U.S. Department  
of Transportation  
**Federal Highway  
Administration**

Refer to: HNG-14

Your August 21 letter to Mr. Gerald L. Eller, Director, Office of Engineering requested the Federal Highway Administration's (FHWA) acceptance of an aesthetic steel post supported timber guardrail developed for use on the Merritt Parkway in Connecticut. Included with your letter were plan sheets and specifications for the Merritt Parkway Guardrail (MPG), an April 1996 test report by Bullard, Menges, and Alberson of the Texas Transportation Institute entitled "Testing and Evaluation of the Merritt Parkway Guiderail," and a composite videotape showing each of the tests that were run.

# MERRITT PARKWAY GUIDERAIL

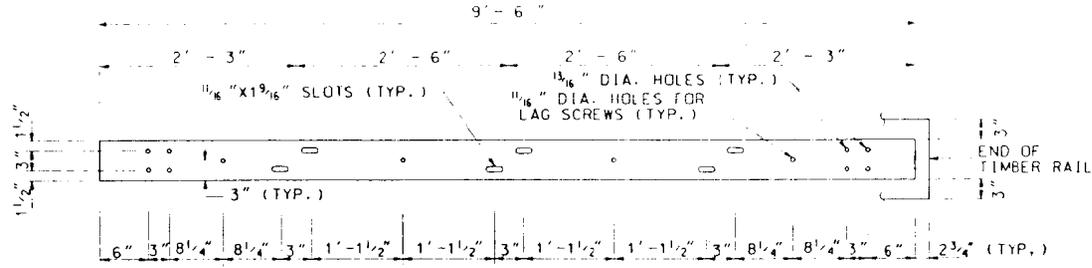
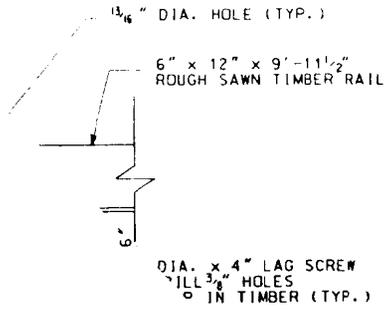
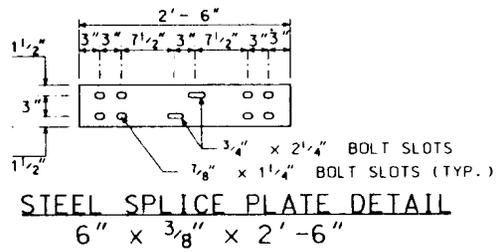
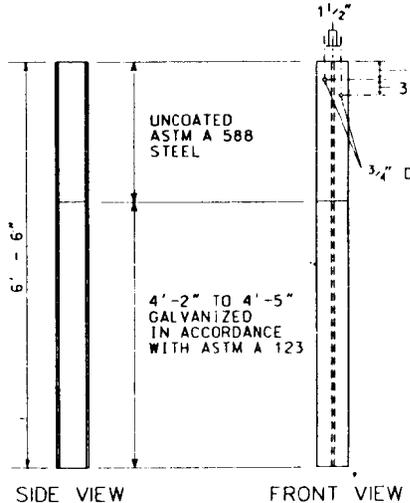
The MPG consists of a 152-mm x 305-mm timber rail element backed by a steel strap and splice plates. This rail is supported by W150 x 22.5 steel posts at a 2896-mm spacing and set with the top of the rail at a height of 762 mm above the pavement surface. Wood blockouts measuring 100 mm x 200 mm x 280 mm separate the rail from the steel posts. Details of the design are shown in Enclosure 1. A transition design, shown in Enclosure 2 was also tested.

We note that you intend to conduct an in-service evaluation of the MPG as recommended in the NCHRP Report 350. Two items of particular interest, in addition to crash performance and repair costs, are the initial cost of the system and the long-term durability of the weathering steel used for the backing plates, splices, and posts.
